<i>NCSX RFD</i> <i>Part I</i>	Number: 14-018R2	RFD Description: Type A2-A6 MCWFs Flange Hole Modifications
Initiator: Mike Griffith		Organization: Major Tool
List of Impacted Documents: ( <i>Specification, MIT/QA Plan, SOW, drawing, etc.</i> ): SE141-114		
Cost Impact: ( <i>If none, so state</i> ): NONE		
Schedule Impact: ( <i>If none, so state</i> ): NONE		
Quality Impact: ( <i>If none, so state</i> ): NONE		
State Requirement Deviation is Requested For: ( <i>Specification, MIT/QA Plan, SOW, drawing, etc.</i> ): SE141-114		
<p>Full Description of the Deviation Requested: (<i>Use continuation pages, e-mails, letter, sketches, etc. as needed and include amplifying information as appropriate to support deviation request.</i>):</p> <p><i>Revision 2 to this RFD corrected Attachment (2) to keep the Type-A, Datum-E, hole #10, as a clearance hole for winding forms A2-A6.</i></p> <p><i>Revision 1 to this RFD removed the Type A1 MCWF– it will be the subject of RFD-14-020. This RFD now only addresses Type A2 through A6 MCWFs.</i></p> <p>Major Tool noted casting interference at the bolt locations as shown in the attached figures for the Type A castings – see Attachment (1). This casting inter

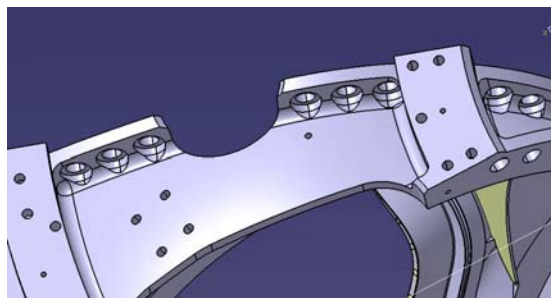
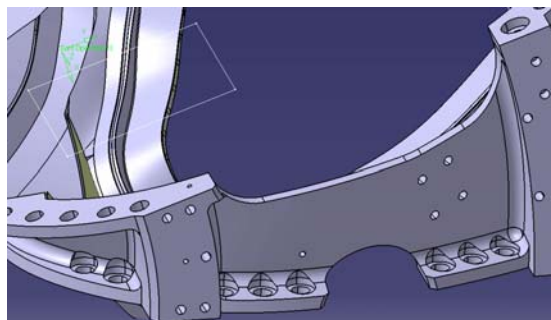
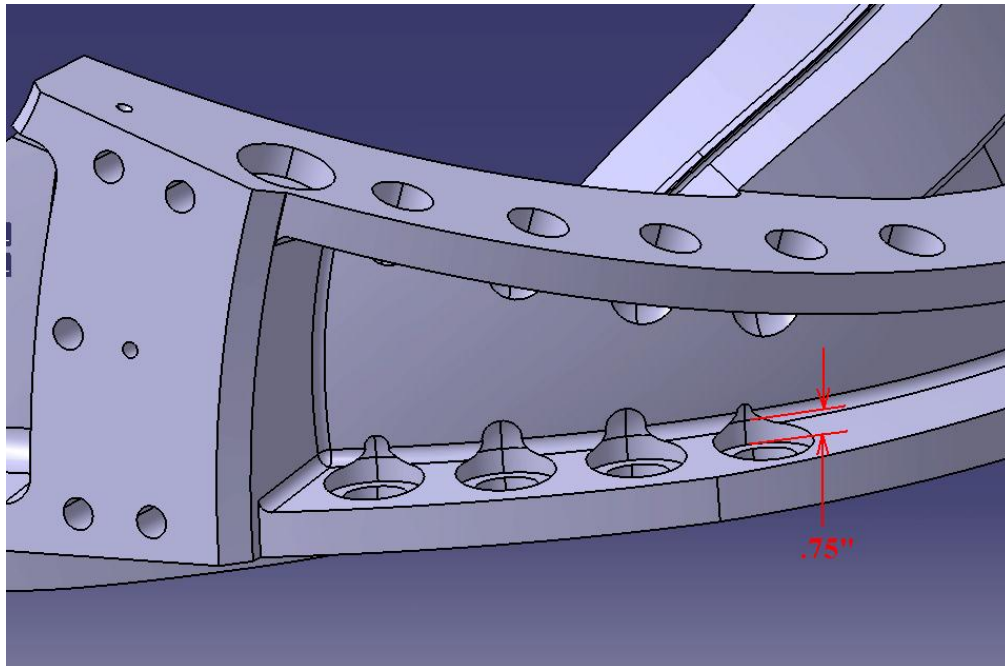
**Relief area cut into cast wall**

The pictures below illustrate how much casting wall interference there will be on the type A casting. The current machining models for all three winding forms have this interference problem to some degree. The models have a 3" counterbore that extends .75" from the face and the remainder of the feature is a 1.5" radius (see below). This is why Major Tool had to perform the grinding around the counterbores on C4 in order to get the 3" diameter gage to fit.
